Drill Rig Technical Review Status

Alaska Department of Environmental Conservation

December 19, 2014

Figure 1: Frequency Distribution of TRANSVAP Run (Infill Drilling) with 10,000 Simulations (Data summarized in Table 1)

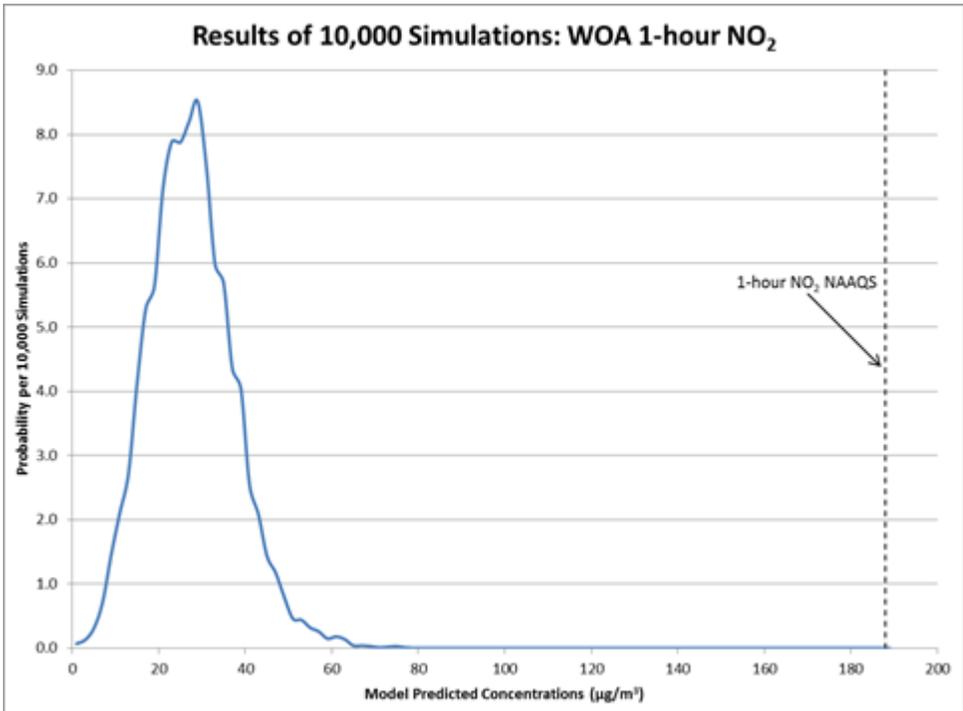
- 1) Are 10,000 simulations adequate?
- 2) Are the results precise?
- 3) Are the distribution parameters conservatively representative?

RDi: Representative Routine Drill Rig Activity Profiles

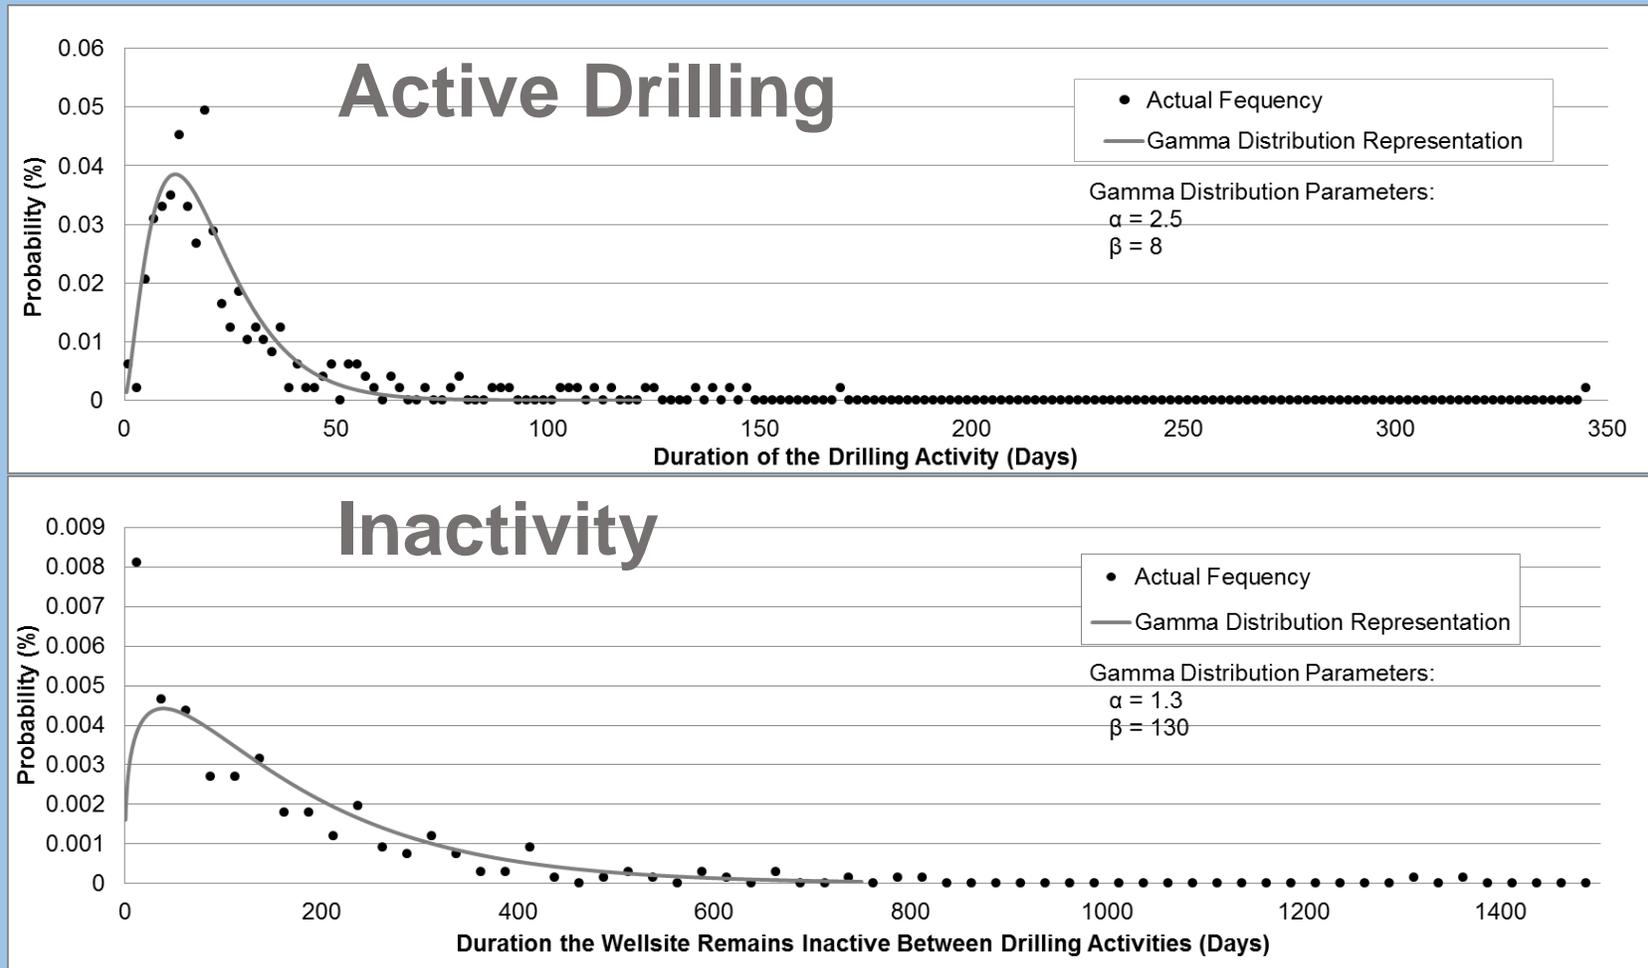
Are the distribution parameters conservatively representative?

Reducing Conservatism - Revised Pad Boundary

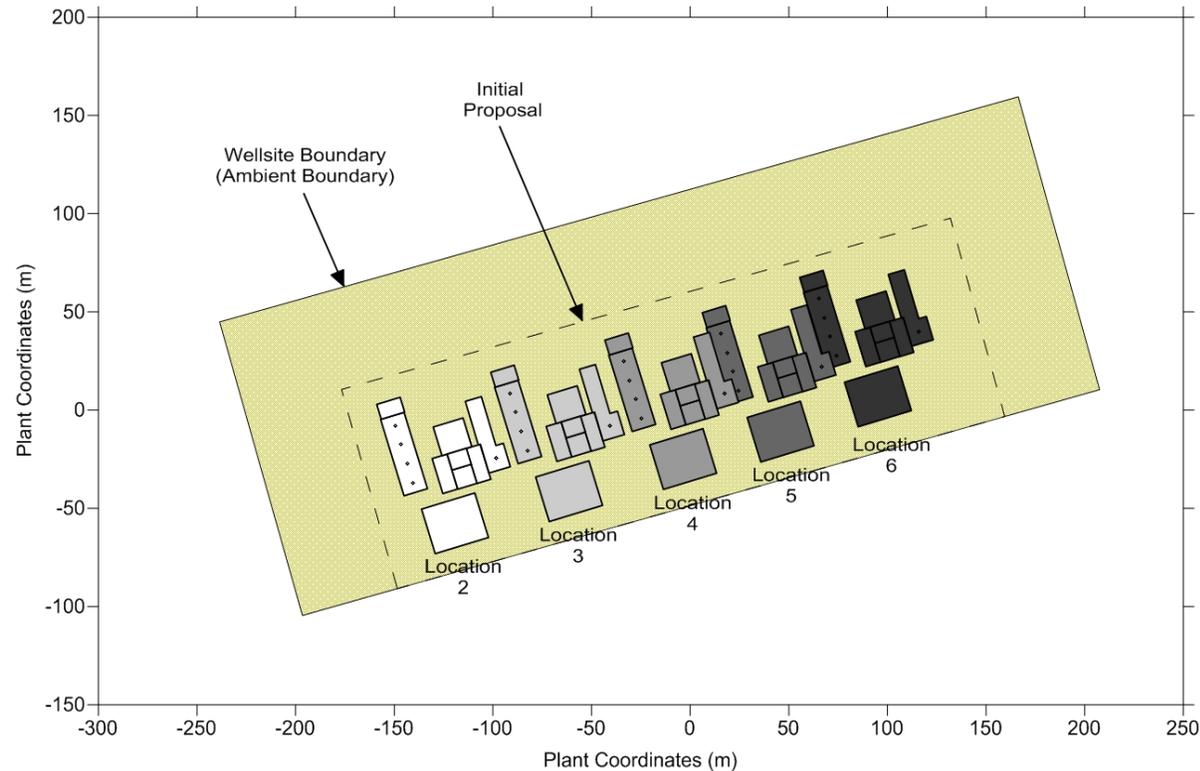
- Industry shortened stack/building heights in response to staff comments
 - Industry said change lead to increased impacts/substantially smaller fuel limits
- Industry then revised additional aspects of North Slope analysis
 - Increased pad size (see following figure)
 - Altered other stack assumptions
 - No collocated stacks
 - Lowered in-stack NO₂/NO_x ratios
- Industry has not yet provided revised modeling files to ADEC
- Said reducing the conservative nature of previous analysis lead to fairly similar fuel limits as originally found

- The pad boundary was extended 50-m on three sides. This is larger than the smallest Alpine pads (CD4), representative of a larger Alpine or Kuparuk Pad, but still smaller than a Prudhoe Bay Pad.
